MIL-L-6363/13
Amendment 1
3 September 1993

MILITARY SPECIFICATION SHEET

LAMPS, INCANDESCENT AIRCRAFT SERVICE, SINGLE CONTACT, BAYONET CANDELABRA BASE, S-11 BULB

This amendment forms a part of Military Specification sheet MIL-L-6363/13 dated 25 September 1992, and is approved for use by all Departments and Agencies of the Department of Defense.

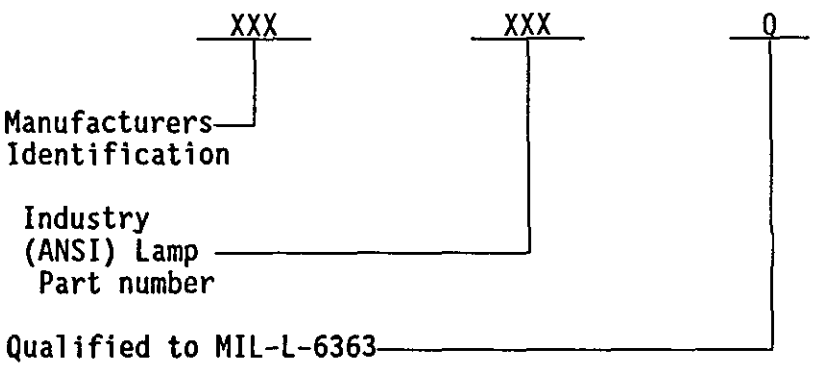
Table I - Add "3/" to PIN column. Add the following footnote under the table: "3/ M6363/13-2 is used in exterior lighting applications."

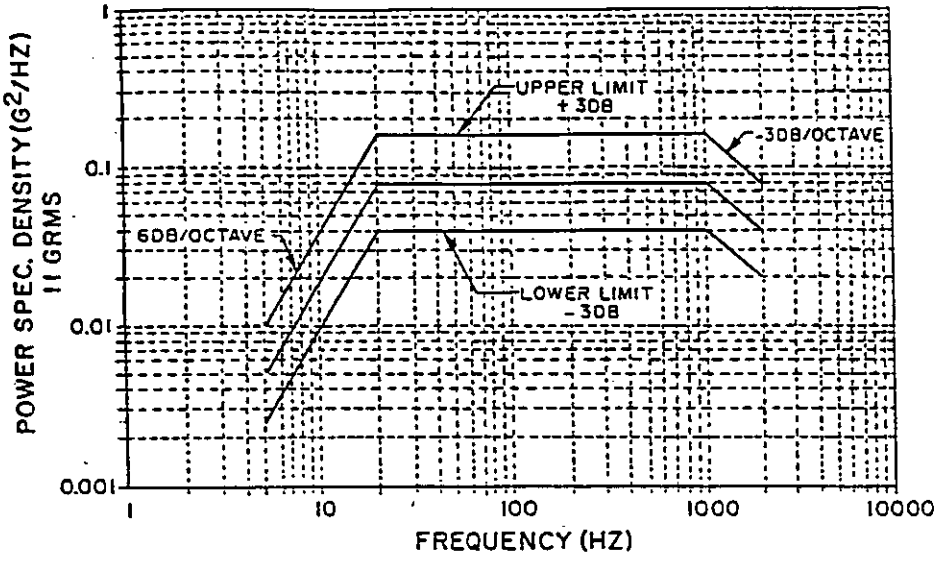
NOTE 4: Qualification by similarity. Delete this note and substitute the following:

"4. Qualification by similarity - M6363/13-2 is required to be fully qualified in accordance with table I of MIL-L-6363. M6363/13-1 may be granted qualification by similarity and extension of qualification from M6363/13-2 with no additional testing. M6363/13-1R may be granted qualification by similarity and extension of qualification from M6363/12-4R with no additional testing. Refer to MIL-L-6363 for conditions and data requirements for qualification.

FIGURE 2B. Random Vibration Curve For M6363/13-2 Lamp

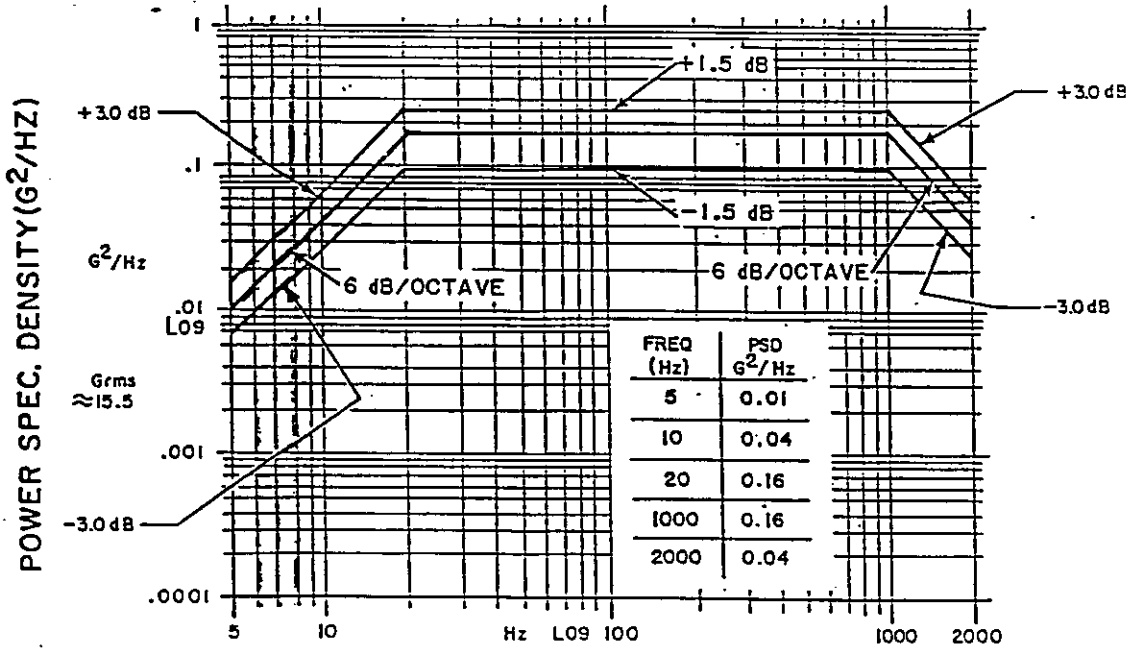
The attached insertable replacement page 3 (Figure 2. Random Vibration Curve) is a replacement for page 3 of MIL-L-6363/13. When the new page has been entered into the document, insert this amendment as the cover sheet to MIL-L-6363/13.

Freq Hz	Vibration Level PSD (G^2/Hz)	Upper Limit (+3 DB) PSD (G^2/Hz)	Lower Limit (-3 DB) PSD (G^2/Hz)
5	0.005	0.01	0.0025
10	0.02	0.04	0.01
20	0.08	0.16	0.04
1000	0.08	0.16	0.04
2000	0.04	0.08	0.02
